Access Compliance Report

Public Rights-of-Way

(Curb Ramps)

Intersection ID: 5104	Main Street: E_MALLARD_CREEK_CHURCH_RD	Cross Street: MARY_ALEXANDER_RD	Location: S
ADA ID: 552C5D244A2C	Ramp Type: Perp	Initial Pass/Fail: Fail	Overall Compliance: No
			Severity Score: 33.75
Codes/Mitigation Info/Possible Solution		Field Measurements/Component Compliance

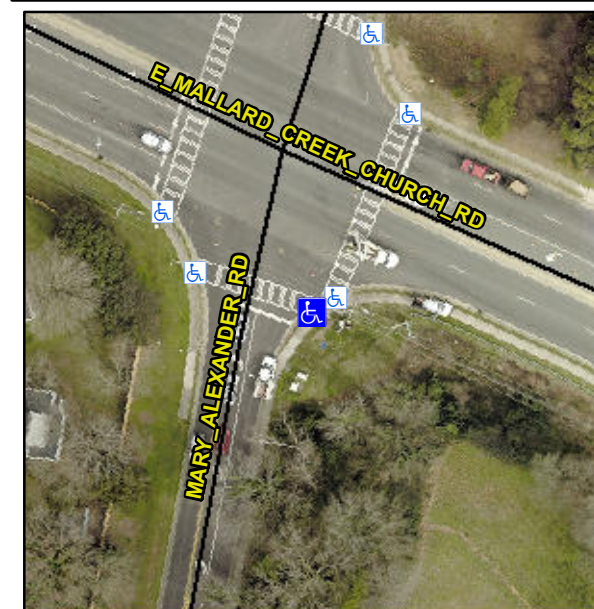
R304.5.1, R304.5.3

Compliance	Description	Data	Compliance	Description	Data
N/A	Ramp Length (in)	70.0	Yes	Ramp Slope (%)	7.7
No	Ramp Width (in)	47.0	No	Ramp XSlope (%)	13.0
N/A	Flare Type LT	N/A	N/A	Flare Type RT	N/A
N/A	Flare Slope LT (%)	N/A	N/A	Flare Slope RT (%)	N/A
N/A	Flare Traversable LT?	N/A	N/A	Flare Traversable RT?	N/A
N/A	Landing Length (in)	N/A	N/A	DWS Provided?	N/A
N/A	Landing Width (in)	N/A	N/A	DWS Contrast?	N/A
N/A	Landing Slope (%)	N/A	N/A	DWS Length (in)	N/A
N/A	Landing X Slope (%)	N/A	N/A	DWS Full Width?	N/A
N/A	Landing Curb? (Y/N)	N/A	N/A	DWS Offset (in)	N/A
N/A	Shared Landing?	N/A			
N/A	Gutter Ponding?	N/A	N/A	Gutter Slope (%)	N/A
N/A	Gutter Lip Ht (in)	N/A	N/A	Gutter X Slope (%)	N/A
N/A	Painted X Walk1?	Yes	N/A	Painted X Walk2?	N/A
	X Walk 1 Direction	To NW		X Walk 2 Direction	N/A
N/A	X Walk 1 Width (in)	109.0	N/A	X Walk 2 Width (in)	N/A
	X Walk 1 Slope (%)	4.4		X Walk 2 Slope (%)	N/A
	X Walk 1 X Slope (%)	10.5		X Walk 2 X Slope (%)	N/A

Remove & Replace Entire Ramp.
